EPC STORMWATER REVIEW COMMENTS ARE
SHOWN IN ORANGE BOXES WITH BLACK TEXT

Preliminary & Final Drainage Report
for
The Sanctuary Filing 1
at
Meridian Ranch

EL PASO COUNTY, COLORADO

May 2022

FIGURE 7

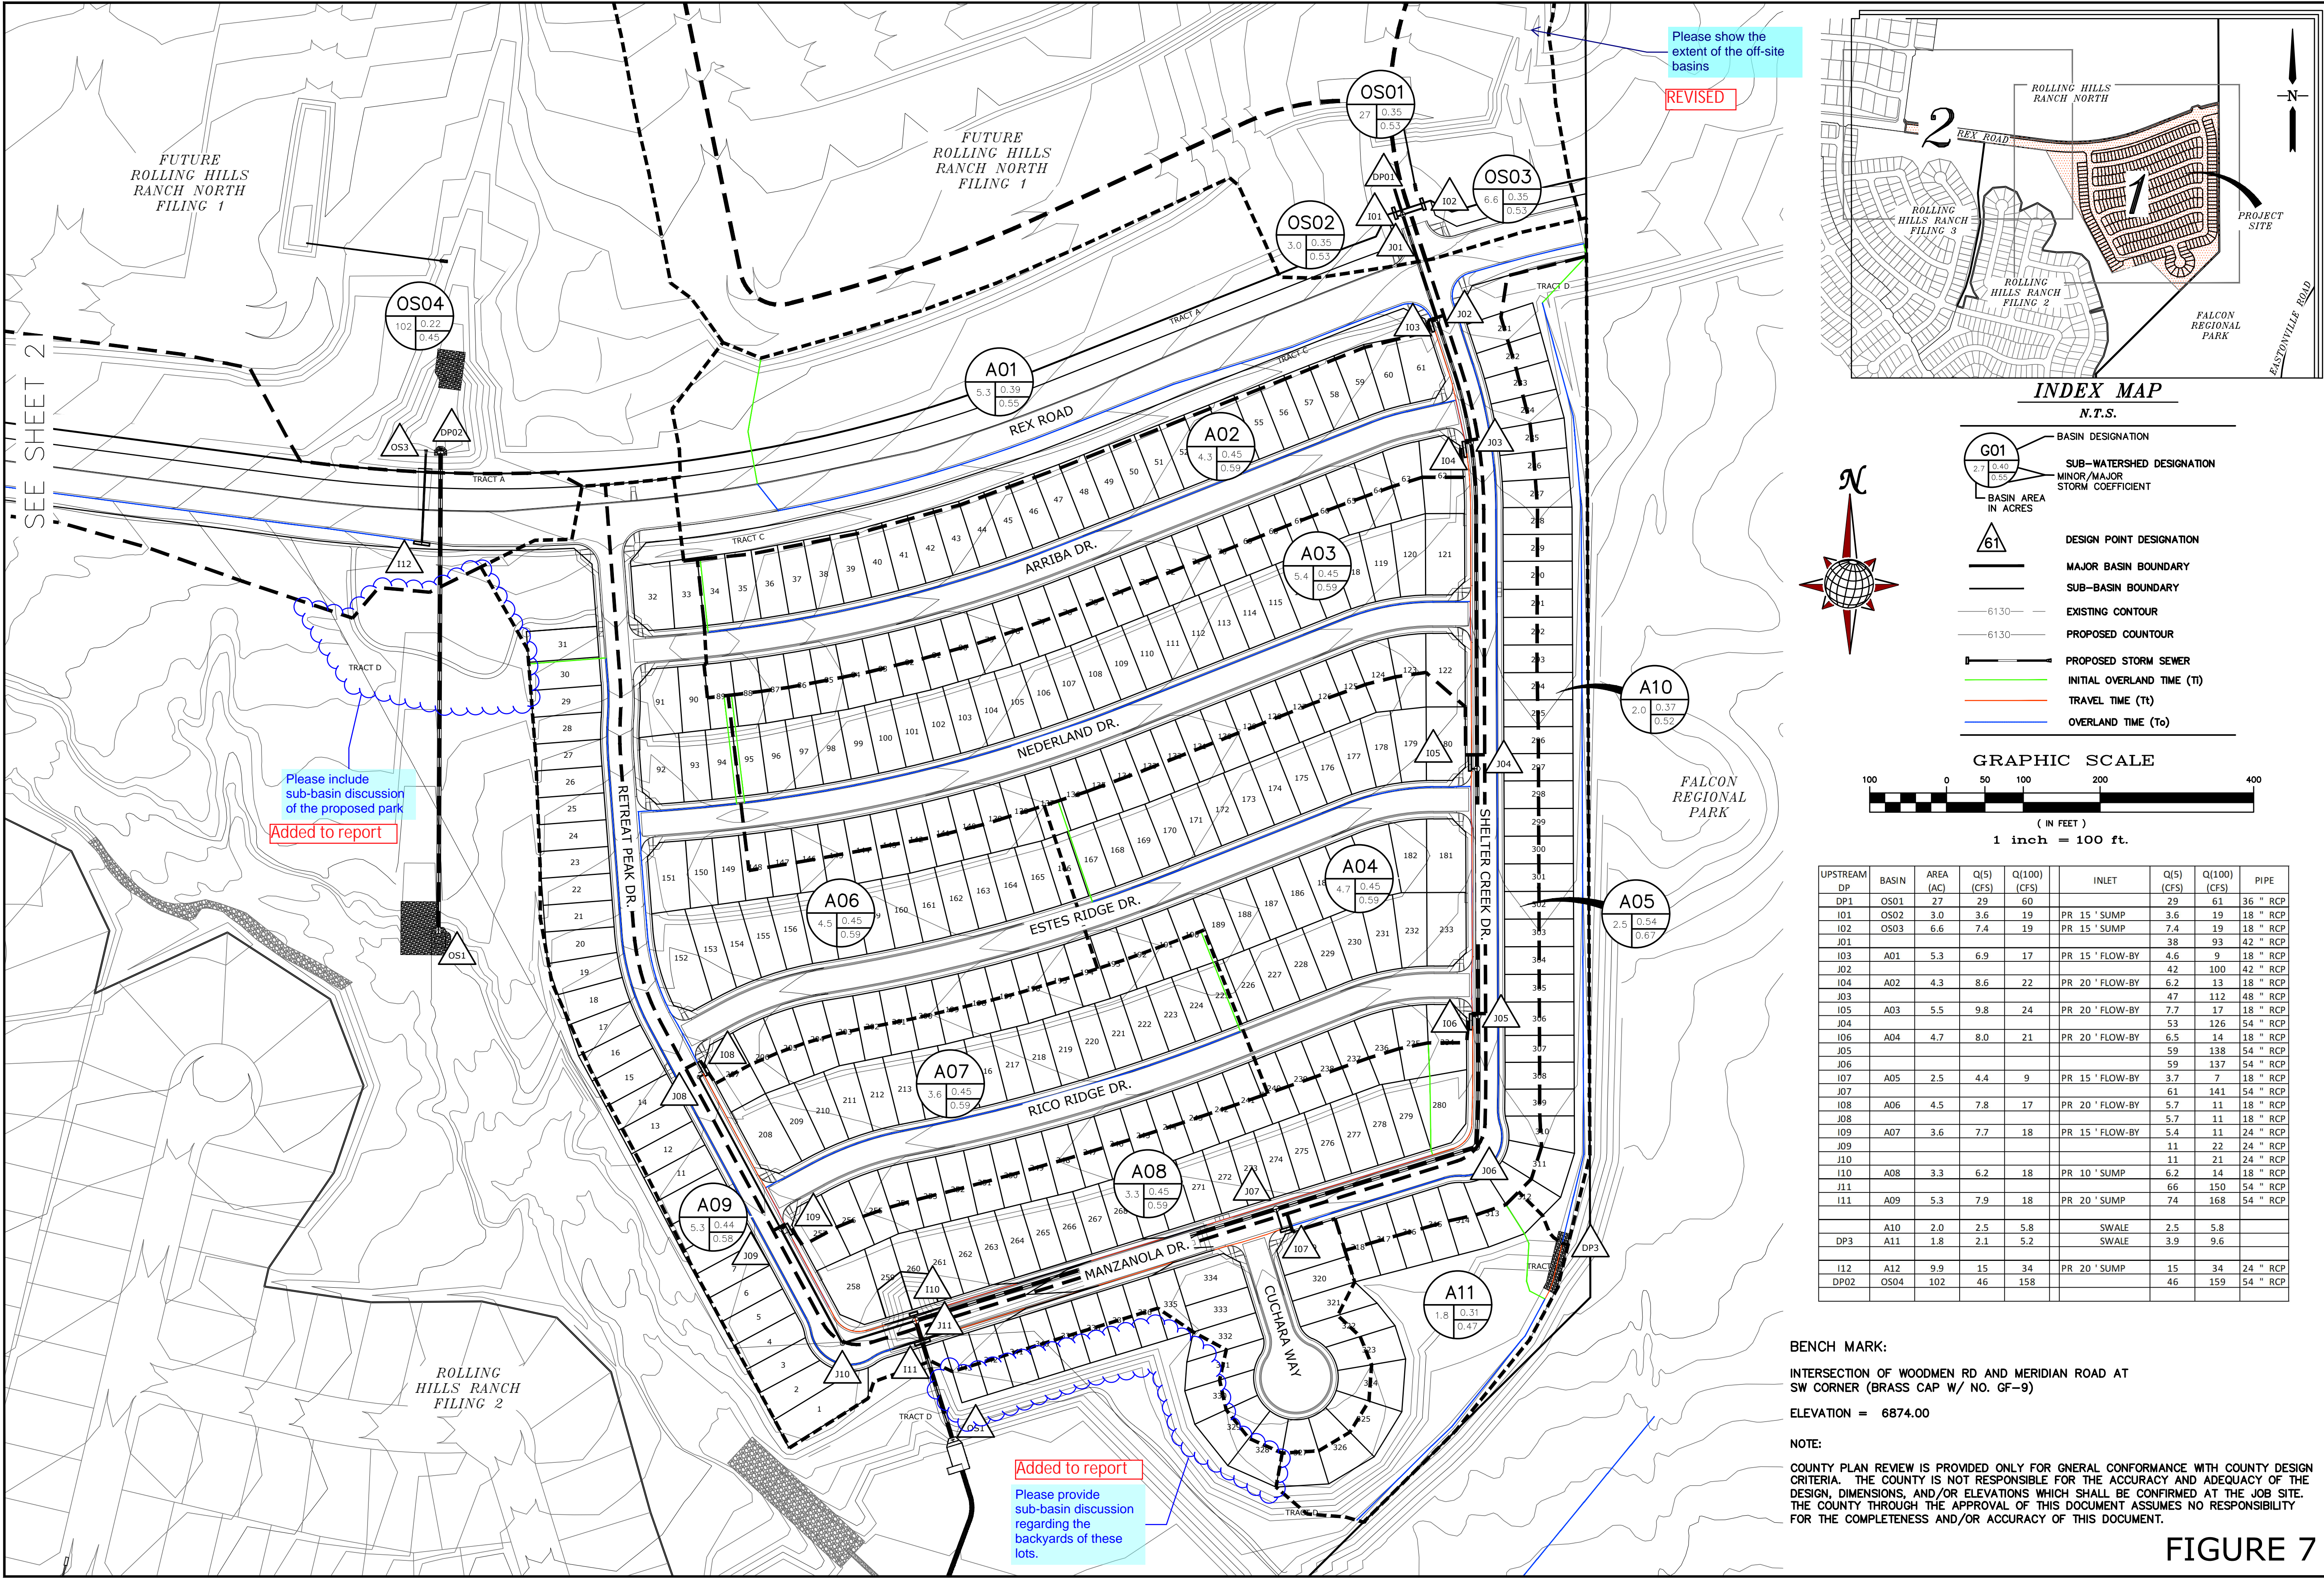
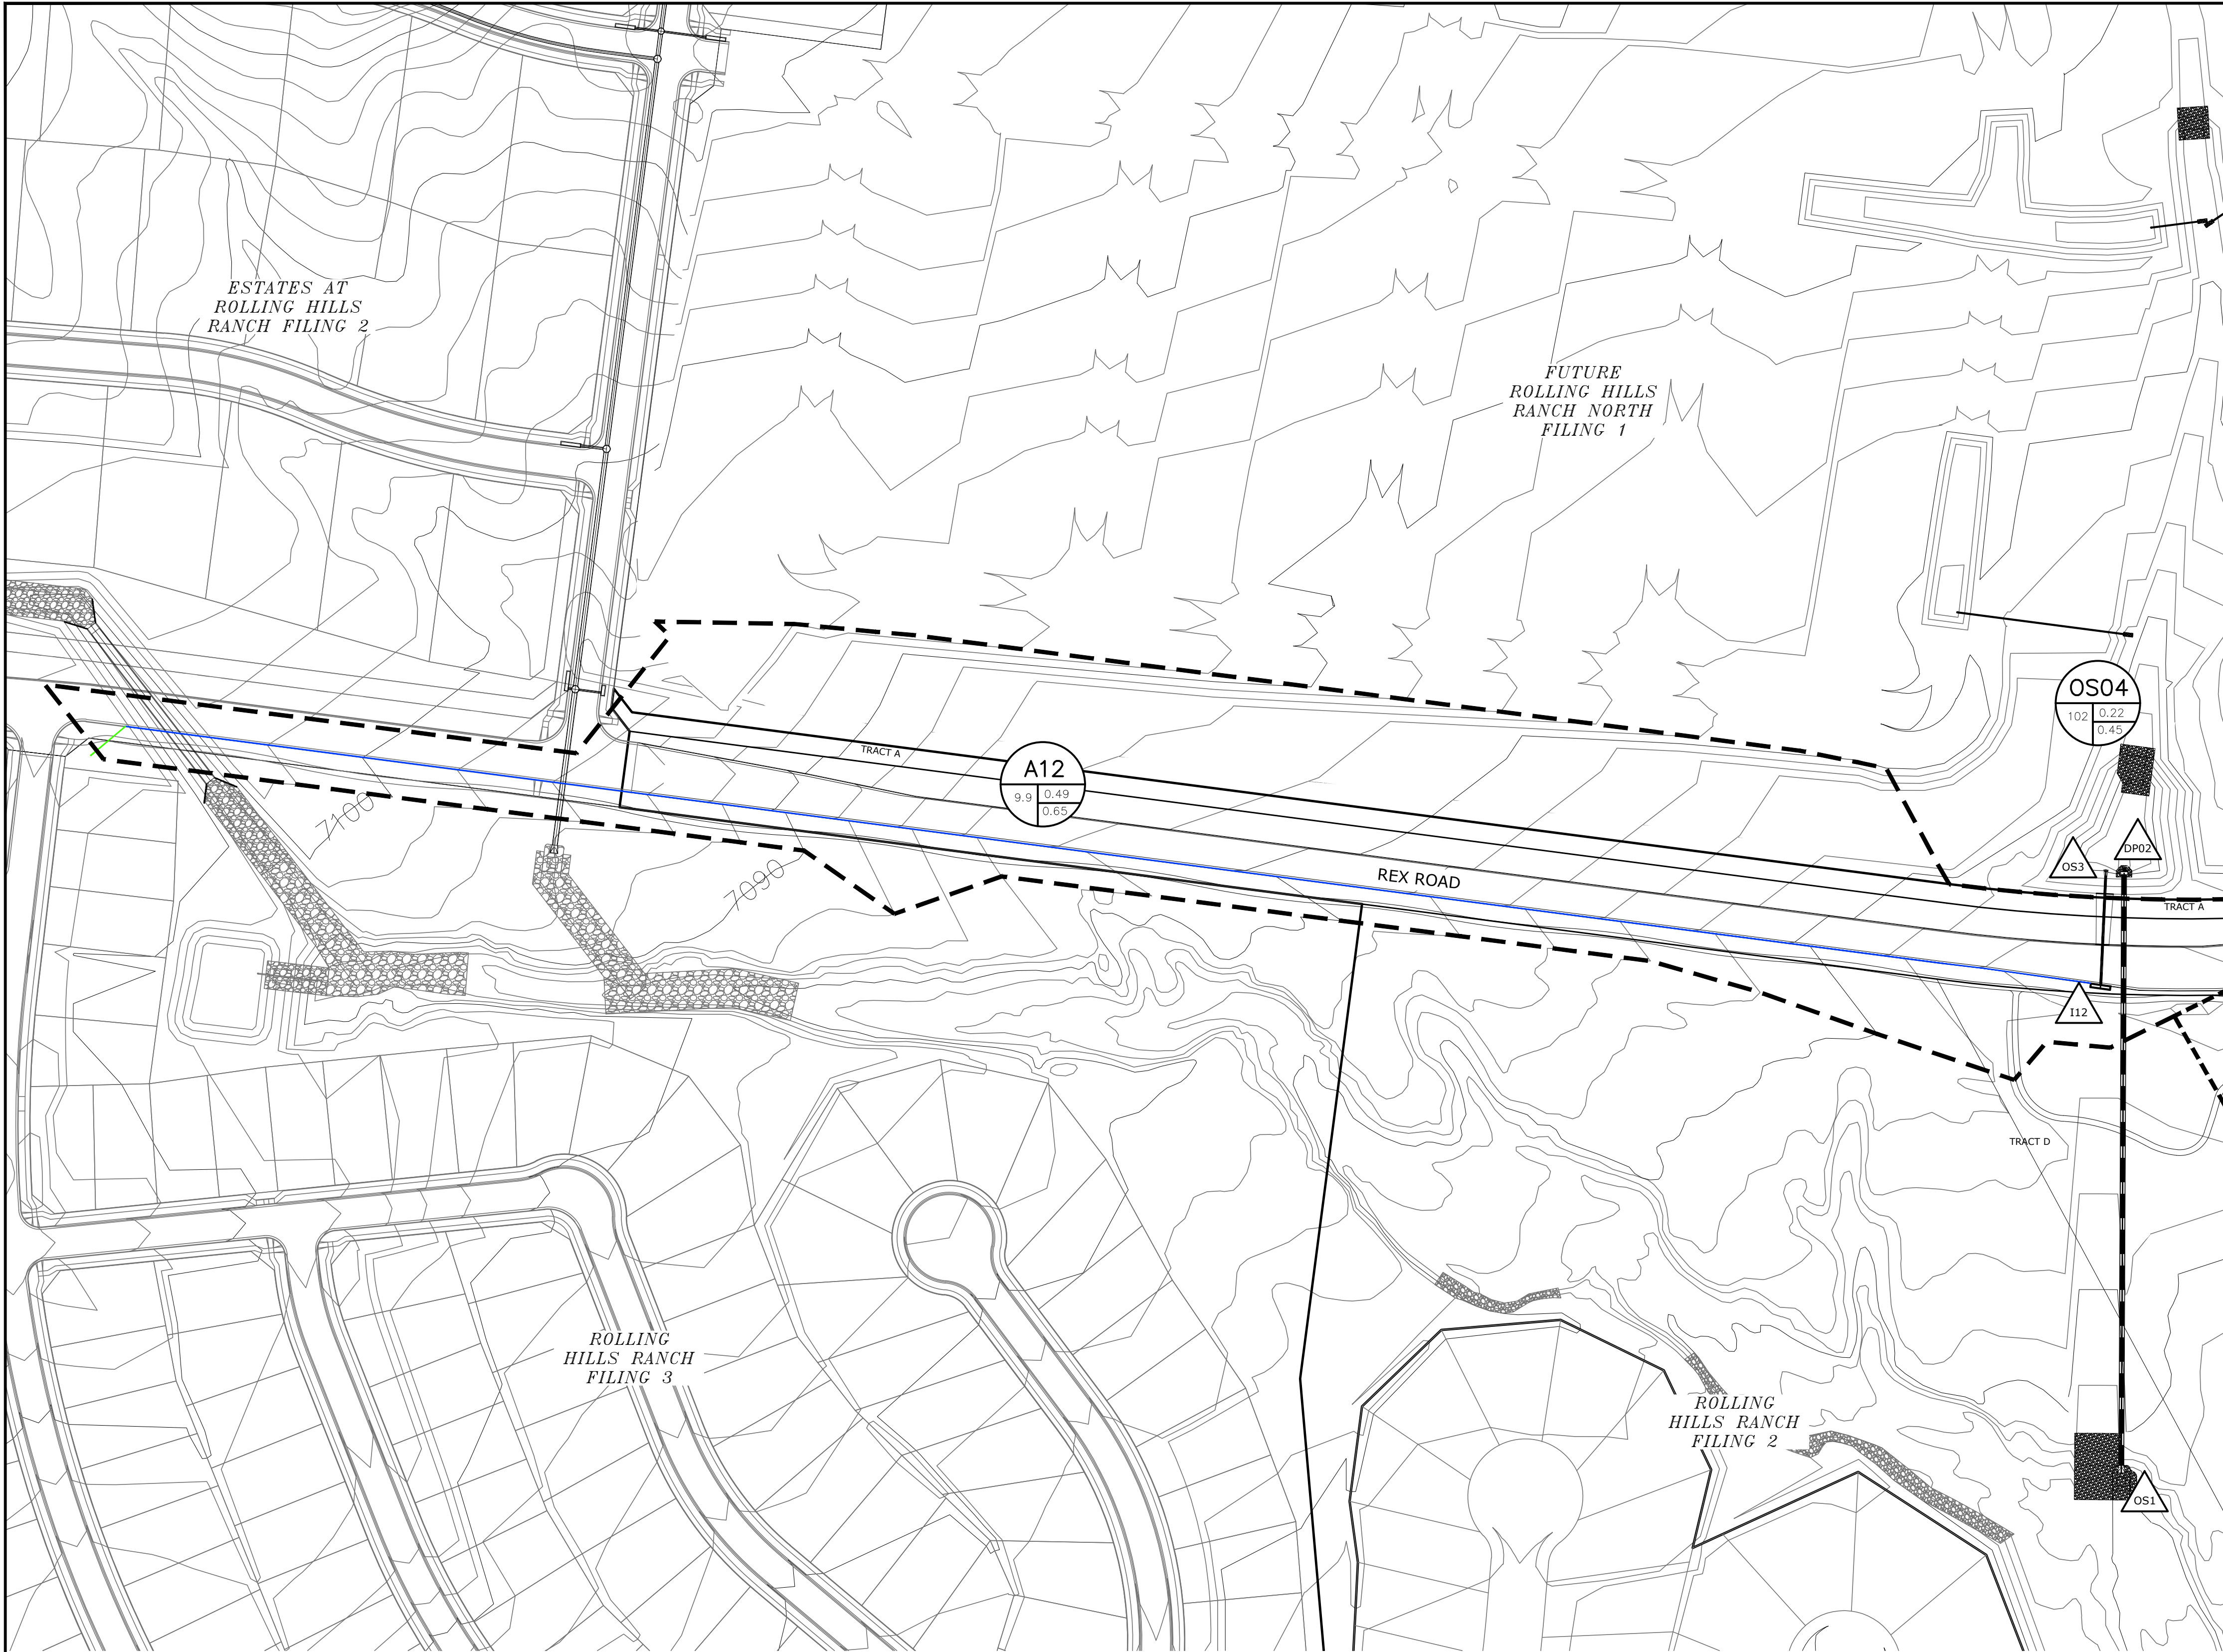
Please show the extent of the off-site basins
